## **Bieson Pty Ltd C/- Future Urban Group**

The proposal seeks the demolition of all buildings on site with the exception of the State Heritage Place (façade and canopy) at 64 King William Street, and the construction of a 15 storey mixed-use office and retail building with ancillary vehicle parking and end of trip facilities

**52-66 King William Street, Adelaide**

<b>Application No</b>	020/A043/20
<b>Unique ID/KNET ID</b>	5424 / 2020/13778/01
<b>Applicant</b>	Bieson Pty Ltd
<b>Proposal</b>	15 storey (plus basement) mixed use retail and office building
<b>Subject Land</b>	52-66 King William Street, Adelaide
<b>Zone/Policy Area</b>	Capital City Zone/ Central Business Policy Area 13
<b>Relevant Authority</b>	State Planning Commission
<b>Lodgement Date</b>	30 July 2020 (amended plans 29 October 2020)
<b>Council</b>	City of Adelaide
<b>Development Plan</b>	Adelaide (City) Development Plan, Consolidated 30 April 2020
<b>Type of Development</b>	Merit
<b>Public Notification</b>	Category 1
<b>Representations</b>	N/A
<b>Referral Agencies</b>	ODASA, Heritage South Australia
<b>Report Author</b>	Damian Dawson, Consultant Planner
<b>RECOMMENDATION</b>	Development Plan Consent subject to co

2 DEMOLITION - WEST ELEVATION  
SCALE 1:200

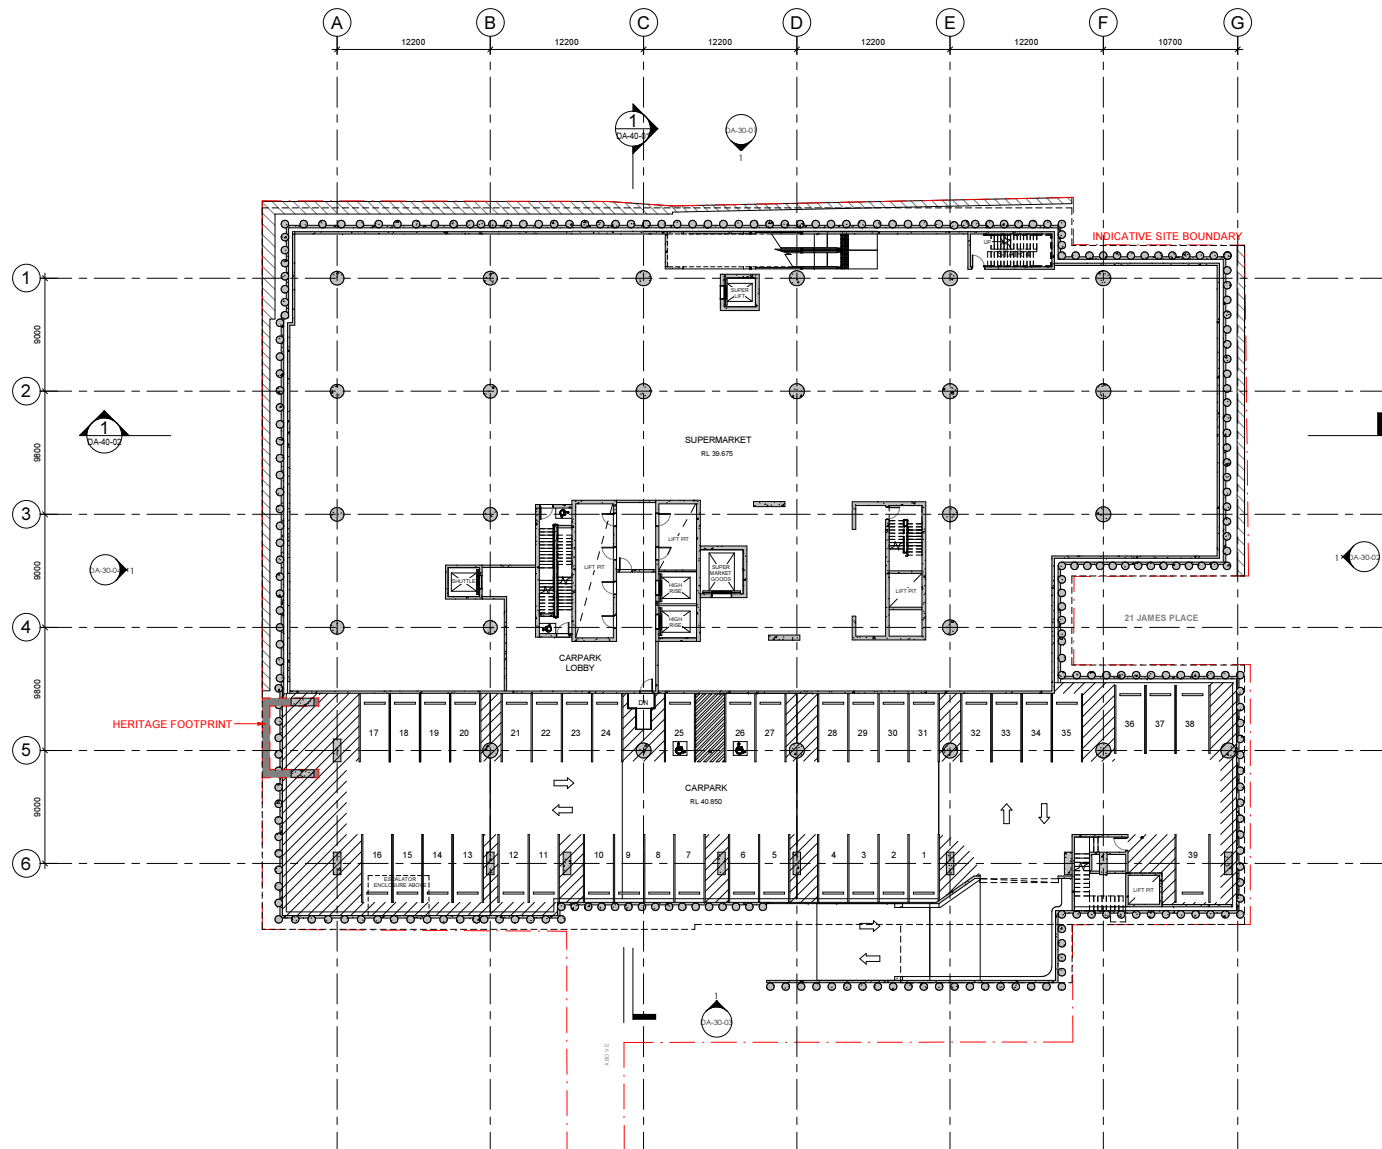
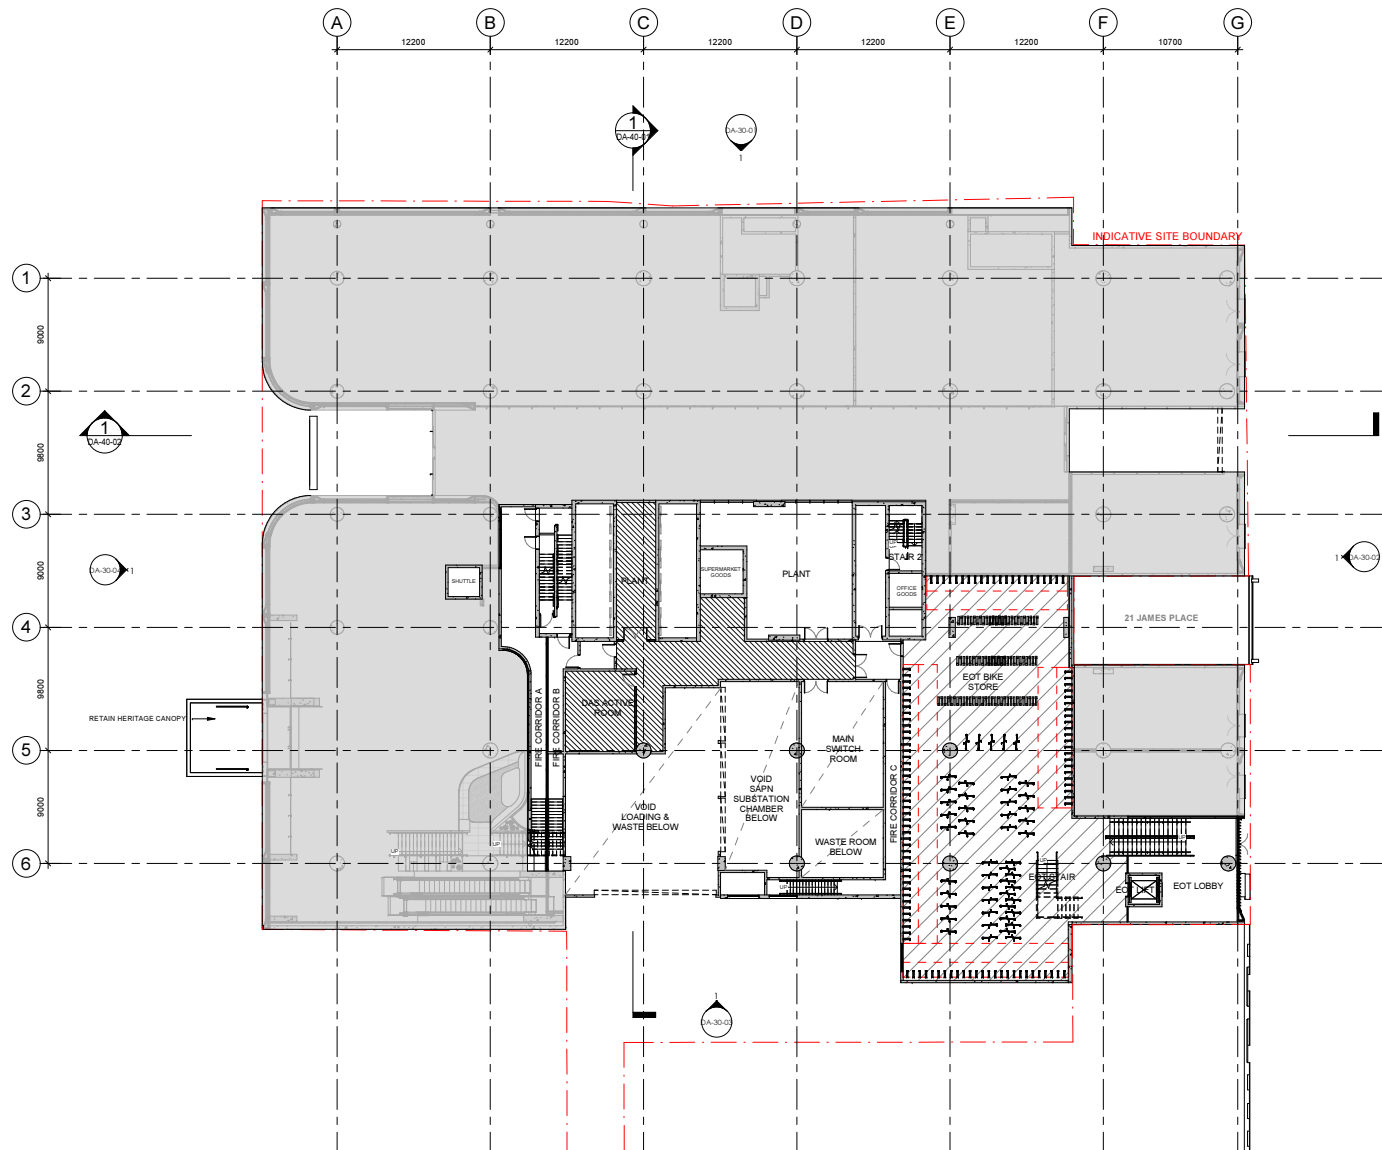
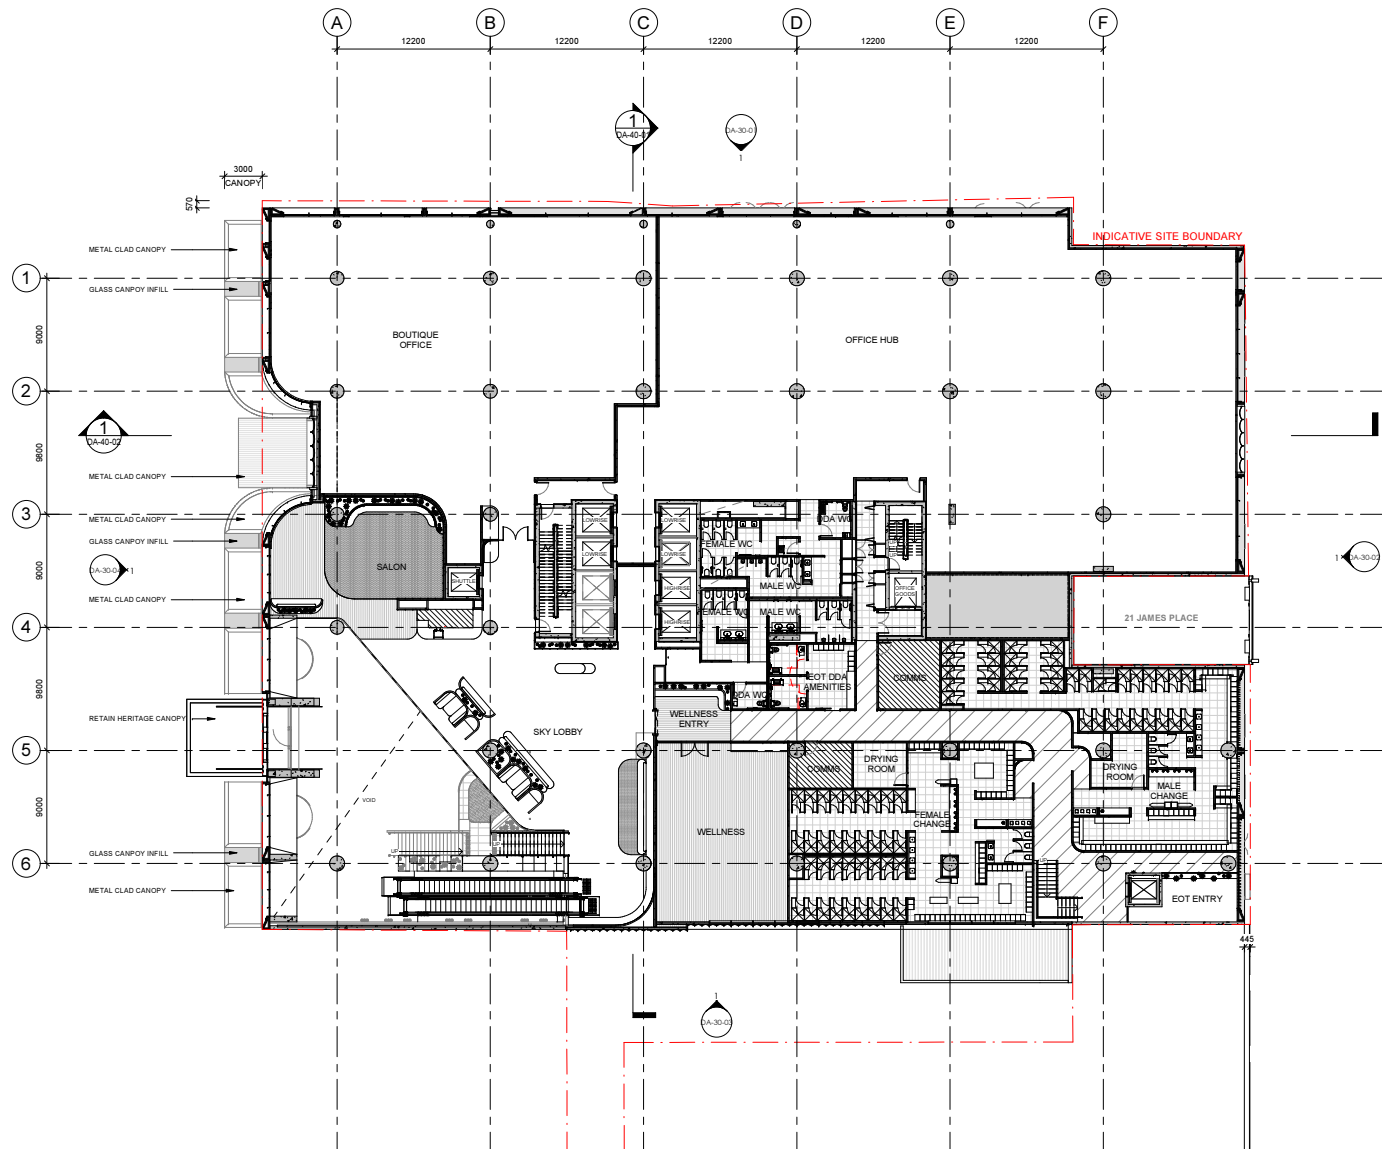
- a) Demolition drawing DA-15-02 West Elevation shows the first and second floor windows being removed. The steel-framed windows and associated wrought iron grilles are an intrinsic component of heritage significance, and their removal is not supported. Re-glazing the original frames may be acceptable subject to further investigation of the existing glass and proposed replacement, and the ability of the sashes to accommodate replacement glass.

- b) Demolition drawing DA-15-02 West Elevation also shows the removal of all below-canopy fabric. Although the existing 1987 shopfront is of no heritage significance, the demolition of other fabric to the sides and above should be informed by first stripping back later facings to determine the extent of significant fabric remaining. Refer to the attached drawing extracts calling for marble facings to be applied as part of the 1933 upgrade. It is recommended that the final extent of below-canopy demolition should be determined once the potential heritage value of any extant underlying fabric has been confirmed.
